**SAN ANTONIO WATER SYSTEM  
CENTRAL WATER INTEGRATION PIPELINE  
TERMINUS TANK PROJECT  
SAWS Job No. 18-8609  
SAWS Solicitation No. CO-00170**

**ADDENDUM No. 3  
March 23, 2018**

**C-1303**

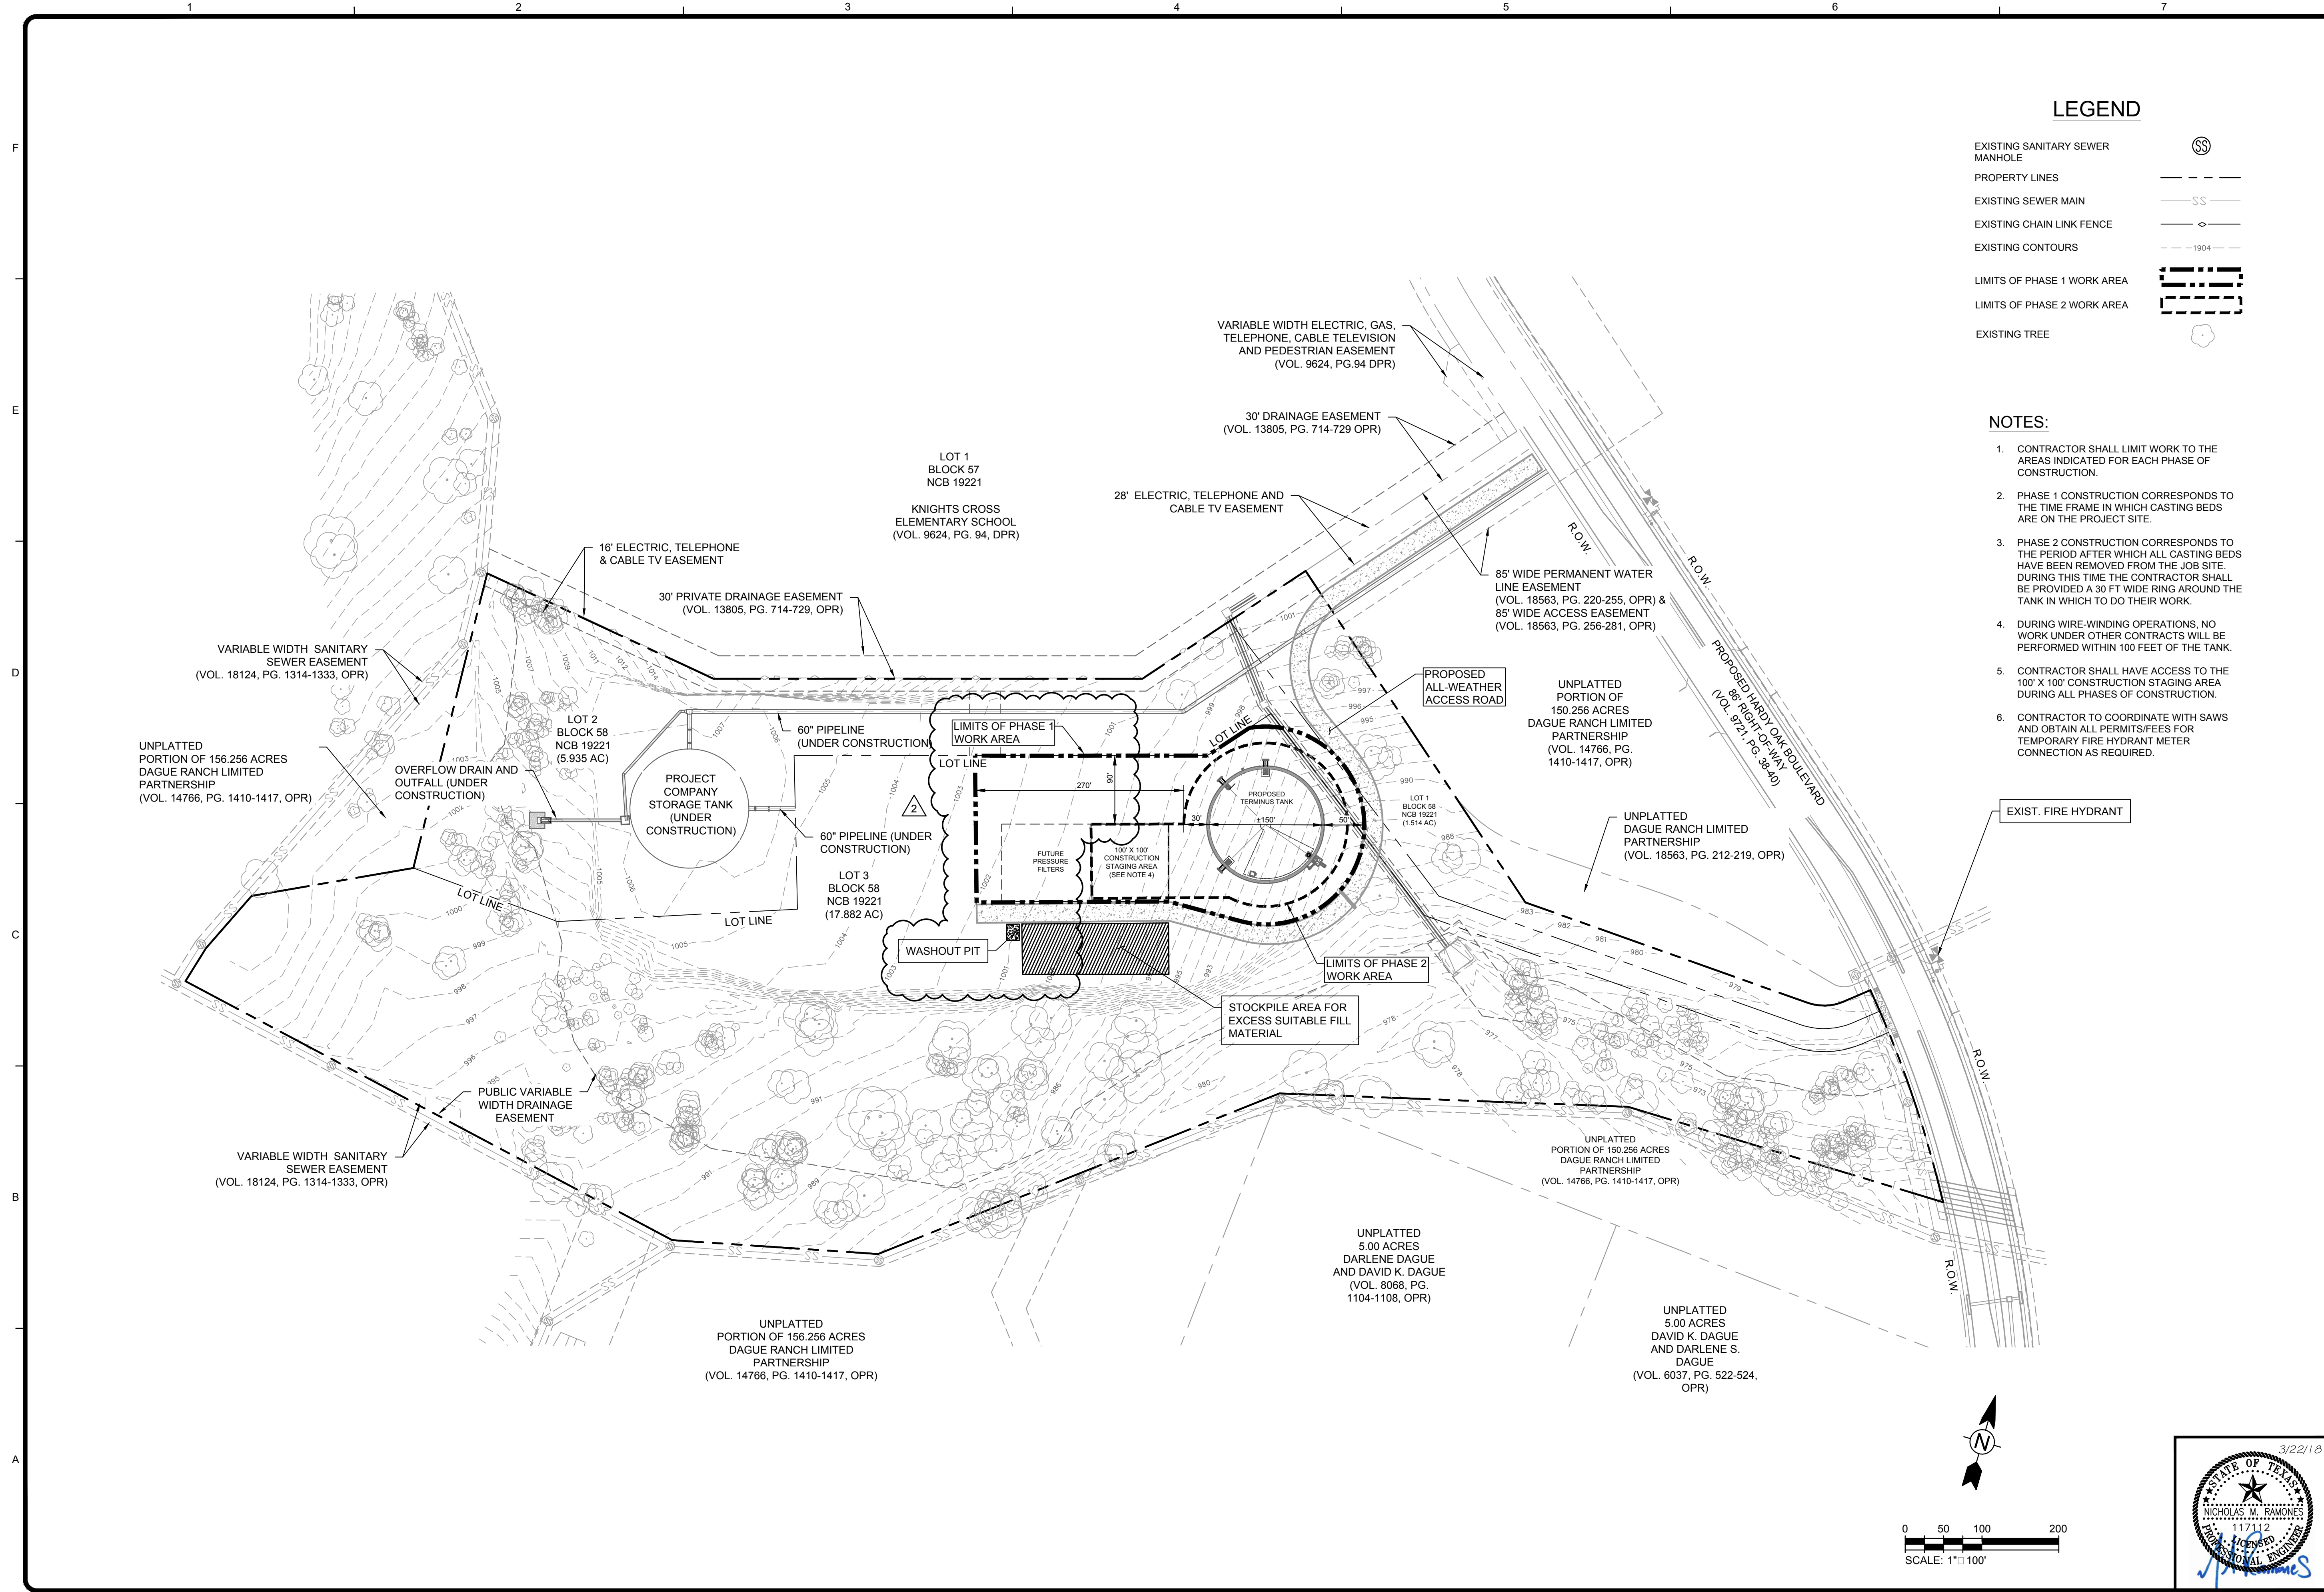
Q16. The amount of area required to assemble the crane for this project is larger than previously anticipated. Crane assembly will require that a temporary work road, with a minimum width of 12 feet, be extended from the tank to a point approximately 300 feet west of the tank, for use during Phase 1. This road would extend approximately 35 feet beyond the western boundary of the Phase 1 Work Area, as shown on Sheet C-1303. Can it be confirmed that a temporary work road may be installed, which would extend approximately 35 feet beyond the western boundary of the Phase 1 Work Area, for use during Phase 1?

A16. Yes, that can be done. As part of this addendum, Sheet C-1303 has been updated to reflect these new limits.

SAN ANTONIO WATER SYSTEM  
CENTRAL WATER INTEGRATION PIPELINE  
TERMINUS TANK PROJECT  
STRUCTURAL GENERAL  
NOTES

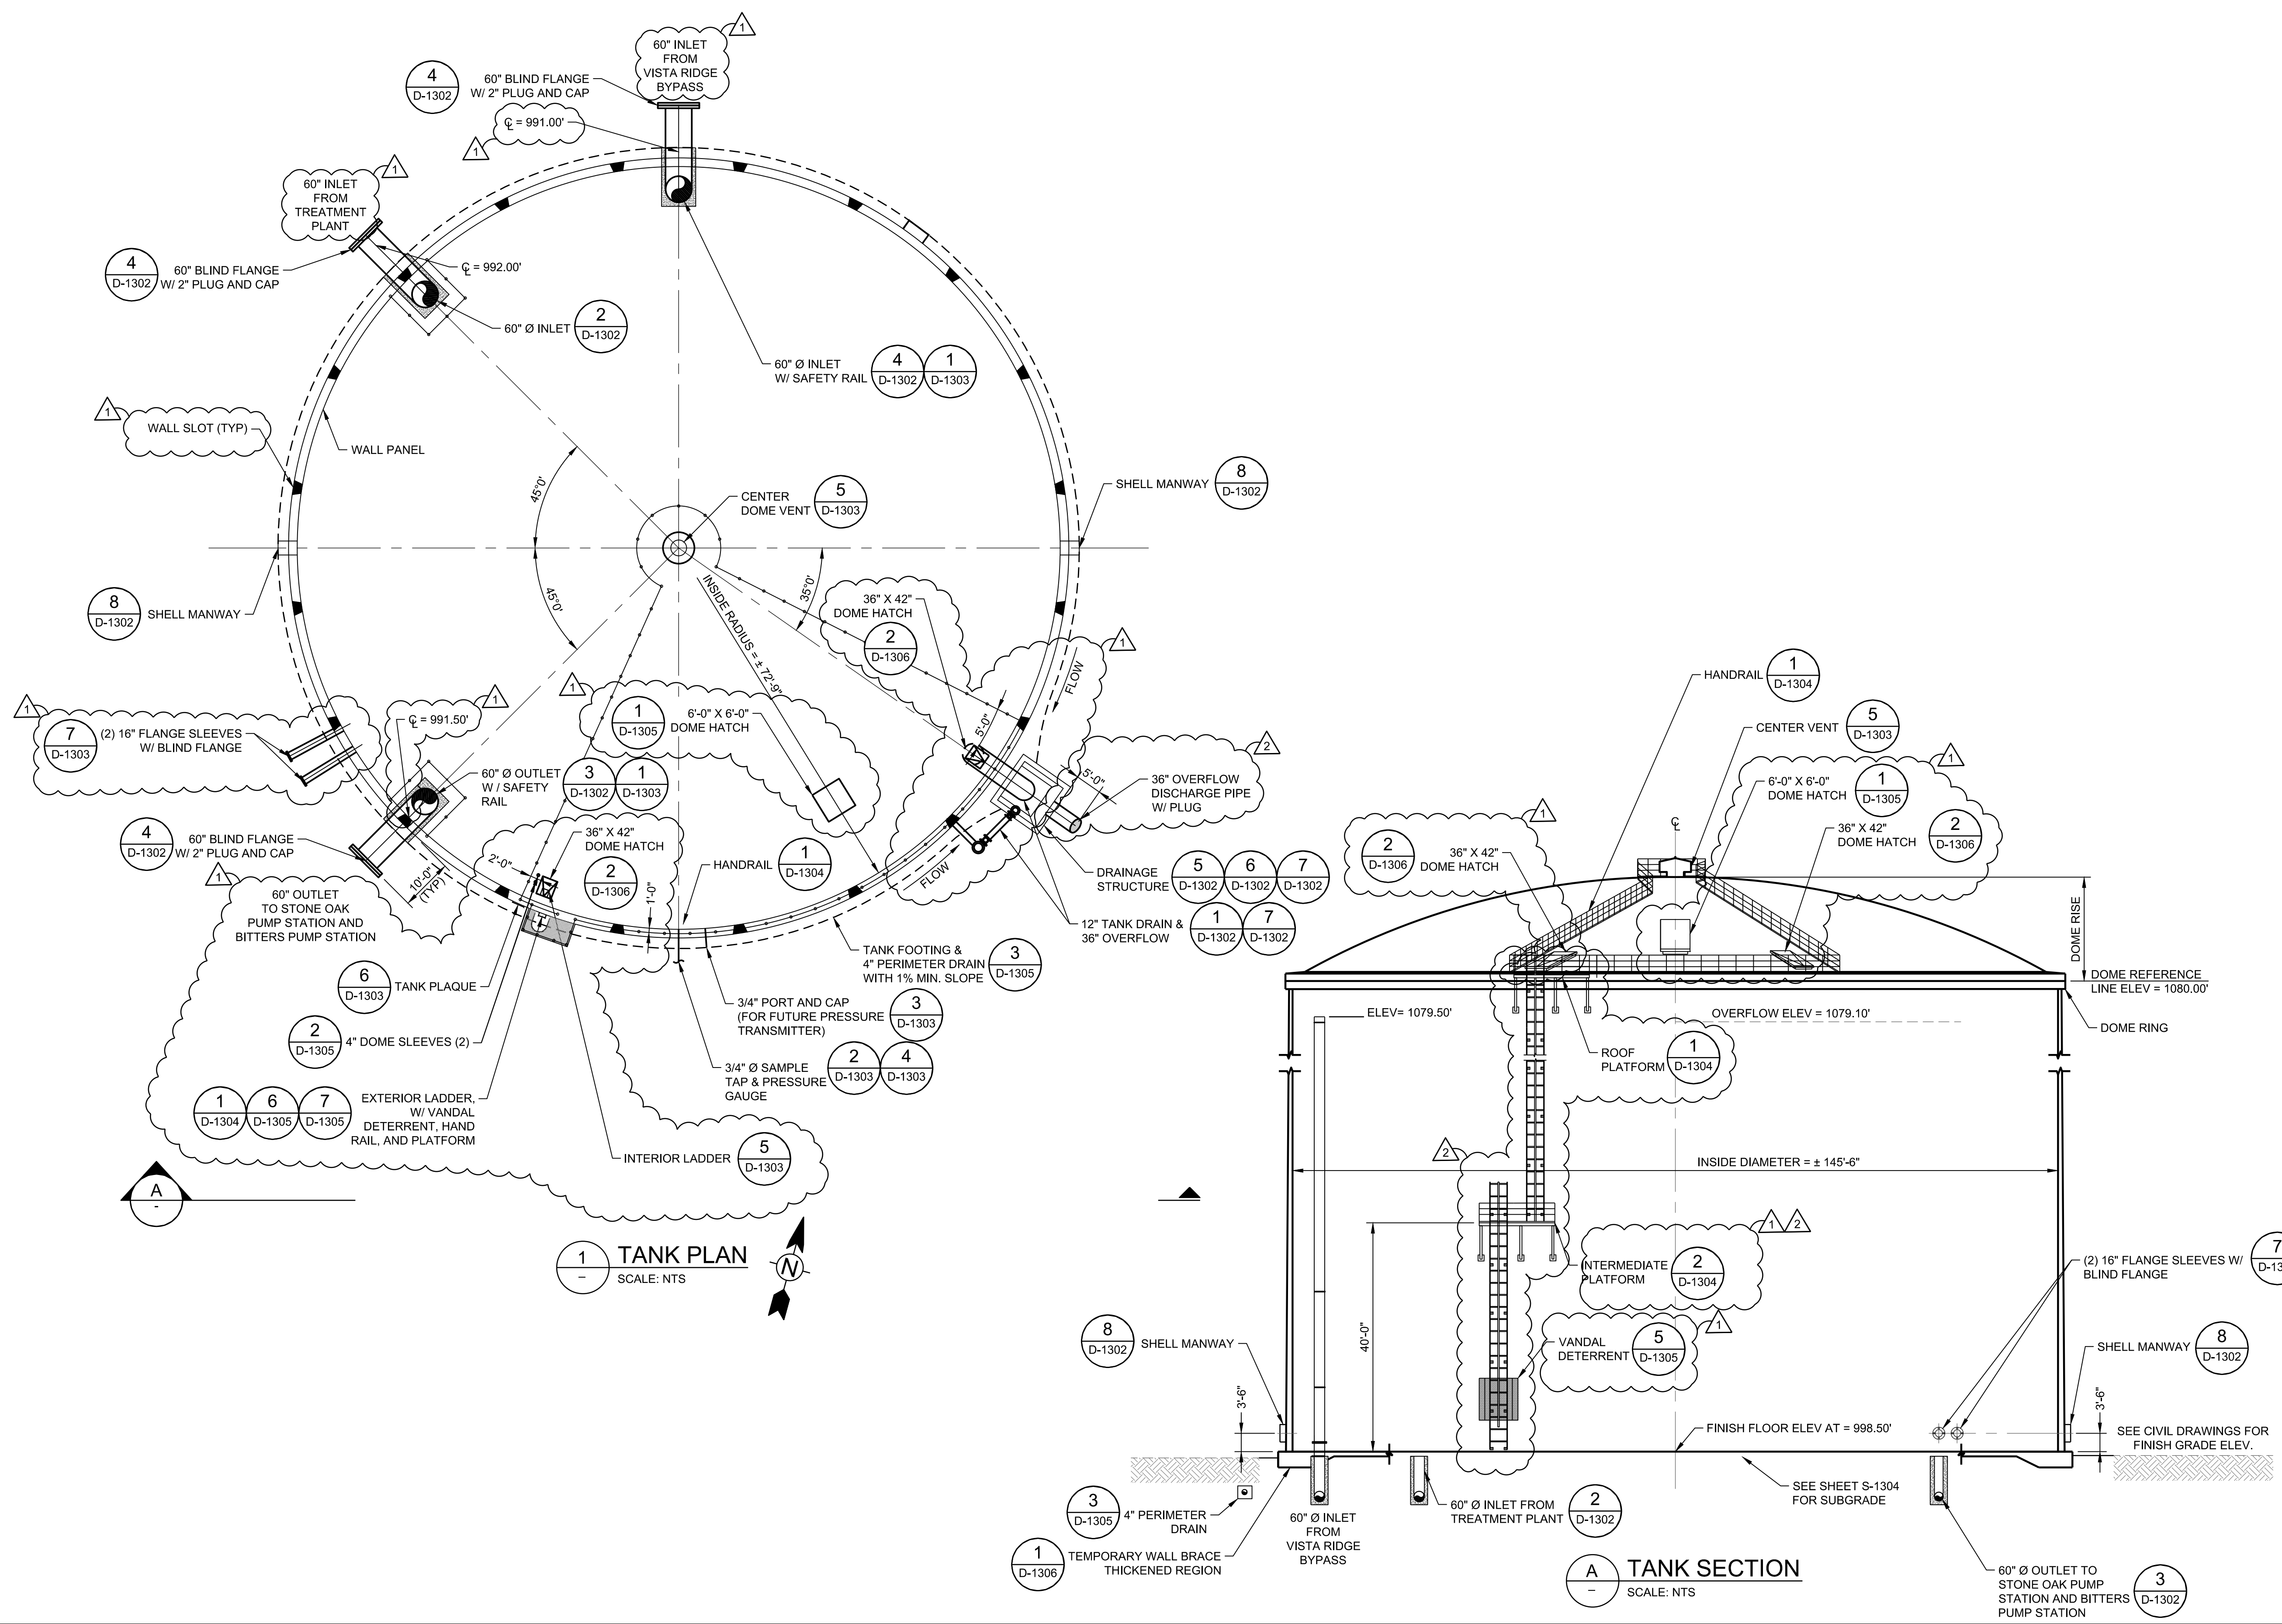
- A14. Section 13207 has been modified to refer to Section 03300 (which lists ASTM C33).
- Q15. Q&A #4 in Addendum No. 2 states that the seismic design criteria shall be per the General Structural Notes as found on Sheet S-1301. The values for  $S_S$ ,  $S_1$ ,  $S_{DS}$  and  $S_{D1}$  shown on Sheet S-1301 (and indicated in the Geotechnical Report) appear to be incorrect, in that they far exceed (by a factor of 10) those values shown on the USGS Seismic Design Maps available on the USGS website. The values shown on the USGS Seismic Design Maps are as follows:  $S_S = 0.074g$ ;  $S_1 = 0.030g$ ;  $S_{DS} = 0.049g$ ;  $S_{D1} = 0.020g$ . Can it

be confirmed that the correct values for  $S_s$ ,  $S_1$ ,  $S_{DS}$  and  $S_{D1}$  are those shown on the USGS Seismic Design Maps?

Q17. With respect to the seismic loads specified in the updated Sheet S-1301:

- The values specified in Note 7 of “Design Load Criteria” in that drawing ( $S_s = 0.74g$  and  $S_1 = 0.30g$ ; and  $S_{DS} = 0.49g$  and  $S_{D1} = 0.20g$ ) are still apparently in error.
- The values of  $S_s$  and  $S_1$  should be  $0.074g$  and  $0.030g$ , respectively (In which case,  $S_{DS} = 0.049g$  and  $S_{D1} = 0.020g$ ).

A15. Yes, that is correct. As part of this addendum, Sheet S-1301 has been updated to reflect those values.

A17. Yes, that is correct. As part of this addendum, Sheet S-1301 has been updated to reflect those values.
